SUBJECT: Oconee Nuclear Station - Unit 2
Docket No. 50-270
Supplemental Information -
Request to use an Alternative to ASME Boiler and
Pressure Vessel Code, Section XI in accordance with
10 CFR 50.55a(a)(3)(ii) (RR 01-08, Supplement 2)

DUKE ENERGY CORPORATION
RELIEF REQUEST 01-08, Supplement 2

RESPONSES TO RAI
REGARDING THE USE OF AN ALTERNATIVE TO
ASME CODE REQUIREMENTS CRDM NOZZLE WELD REPAIR
OCONEE NUCLEAR STATION, UNIT 2
DUKE ENERGY COMPANY

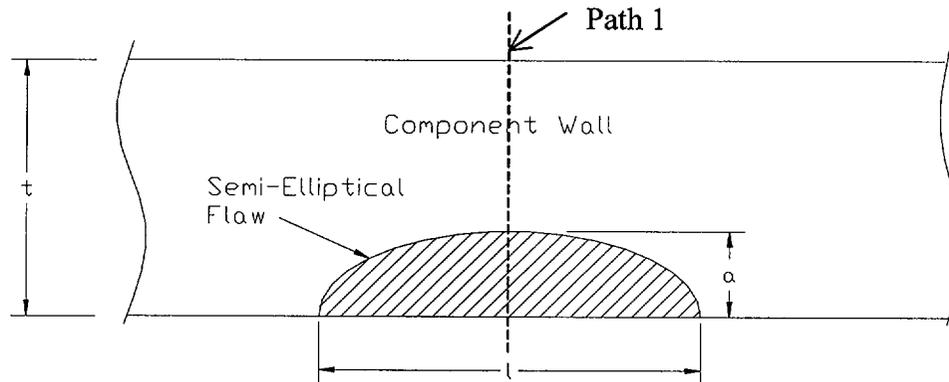
Page 20: It is not obvious from Figure 2 that cracking along Path 2 can be represented by the SIF solution of a semi-elliptical surface crack in a flat plate subjected to radial stresses. Please clarify.

The flat plate model can be visualized as a horizontal disk, with a hole at the inside surface of the new weld,

material during the welding process and the subsequent cooldown to ambient temperature, a pre-service hydro test, and operation at steady state conditions. After the steady state loads were removed, and the structure was again at ambient conditions, the [] portion of the CRDM nozzle was [] the model [] the temper bead weld. The remaining stresses are the residual stresses corresponding to an unflawed structure.

Although the residual hoop stress predicted by the model in the weld region is high, up to about [] psi, the stress decreases to [] at the butter-to-head interface (at the postulated crack tip), and is compressive in the head. These stresses would be relieved as the crack propagates through the weld, and a crack at the butter-to-head interface would experience only compressive stress ahead of the crack.
